# Product Change Notification

**Change Notification #:** 116997 - 00  
**Change Title:** Intel® Server System R1304WF0YSR, PCN 116997-00, Product Design, Label, Update BIOS/BMC/ME/FRUSDR, System outer box J33994-001 stacking logo update, 1100W Power Supply Add URL to BIS mark  
**Date of Publication:** June 14, 2019

Image 1. Power supply label before change

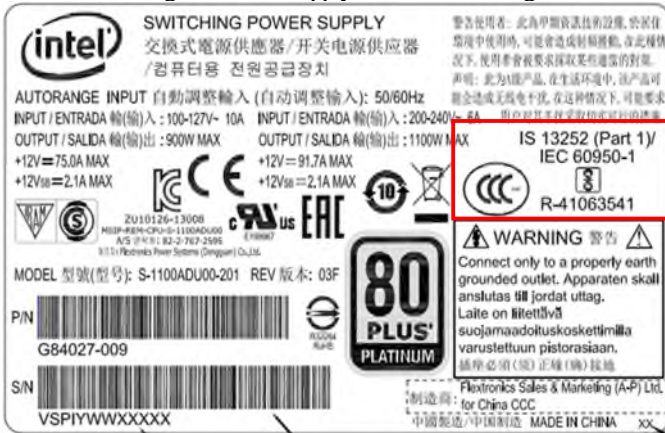
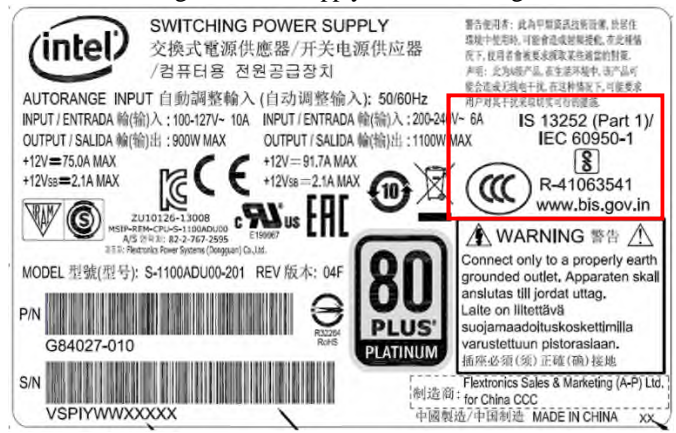
Intel is updating the label of the 1100 power supply. The new label includes a URL of the BIS mark and remove "S&E" inside the CCC logo.

Image 2. Power supply label after change
